# Marine Turbine Series Improvements

## Product Bulletin

**Marine Turbine Series: 900MA, 1000MA, 75900MAX, 73100MA, 75100MAX, 77100MA and 79100MAV**

**Racor introduces the most significant improvements to our Marine (MA) Turbine Series fuel filter/water separators in the last 30 years!**

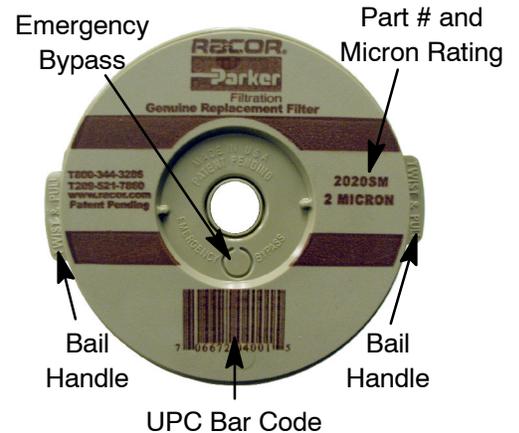
3. **Improved Bail Handles:**

Two opposing handles make the removal of the cartridge easier during servicing.

**Top View of 2020 Cartridge Element**

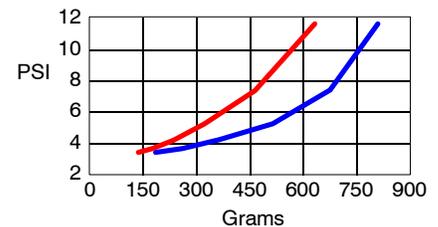
2. **Printed Endcap:**

A color coded, permanently printed top endcap will feature information about the cartridge. Red lettering indicates a 30 micron element, blue is 10 micron, and brown is 2 micron.

SAE J905 Contaminant Capacity (Life) (using SOFTC-2A)

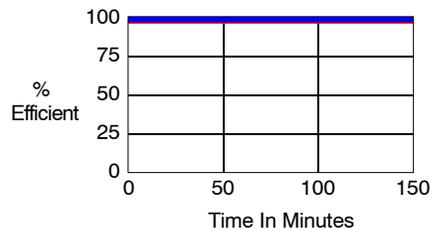
Performance tests on the new 10 micron media have yielded the following improved results (see graphs below). Test data for the *current design* is in **red** and the test data for the *new design* is in **blue**.

#### Partial Half Section and Cutaway View

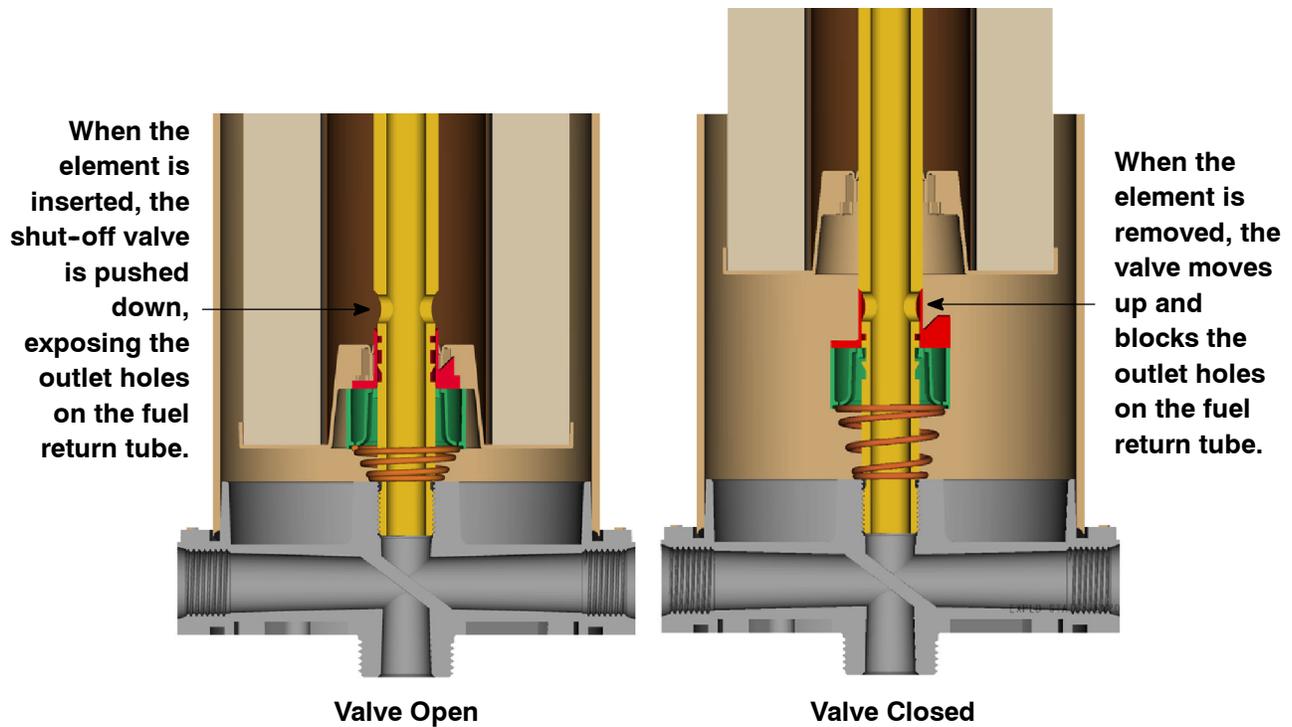
An advanced, patent pending fuel shut-off valve keeps unfiltered fuel from entering clean-side passages during element removal and provides the customer with a consistent prime and less chance for trapped air to circulate through the fuel system. The valve features a steel spring that pushes up on the element to make servicing more convenient and mess free. The valve is activated by inserting or removing the replacement element. As the element is inserted into the assembly, the valve opens and allows only clean fuel to pass to the engine. If the element is removed, the valve closes and stops all fuel flow out of the assembly (see pictures below).

### Redesigned Fuel Return Tube

The redesigned fuel return tube supports the internal fuel shut-off valve and features the outlet hole located at the bottom of the tube (see pictures above).

Current 900MA Assembly

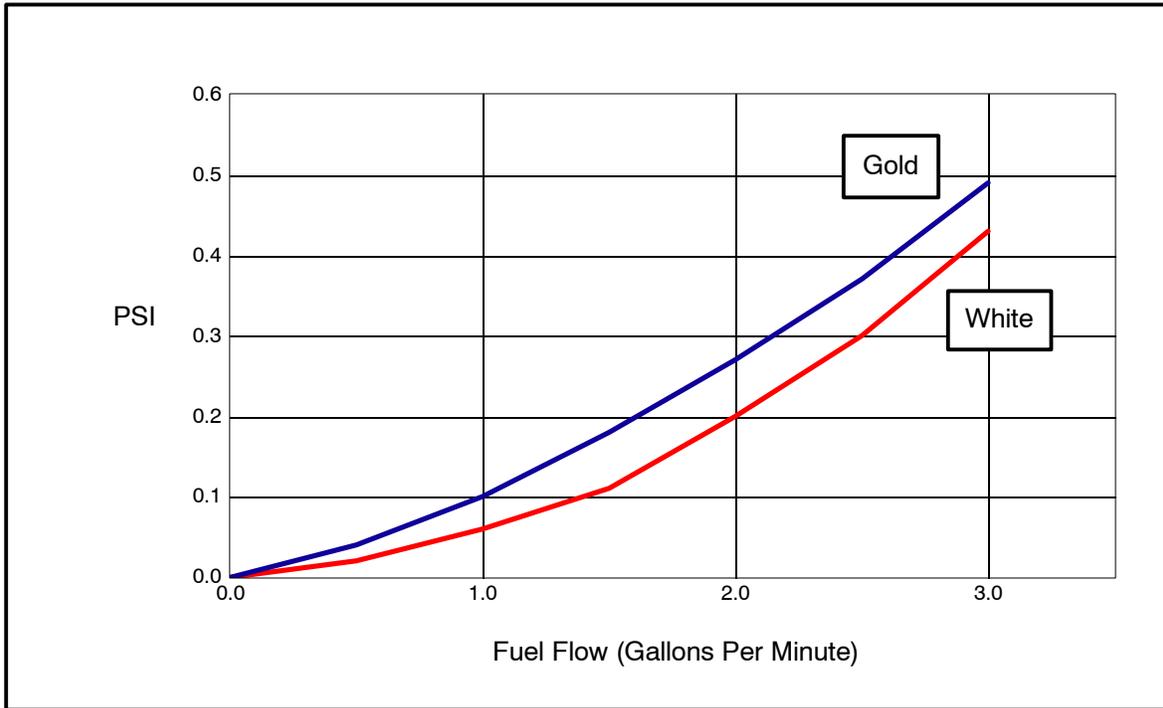
All Racor Marine Turbine (MA) assemblies will showcase a new look - the entire assembly will be white powder coated (see pictures below). This color combination presents a clean appearance that will blend and compliment the majority of installation applications. Note: MAM assemblies will also include a new white metal bowl (not shown).
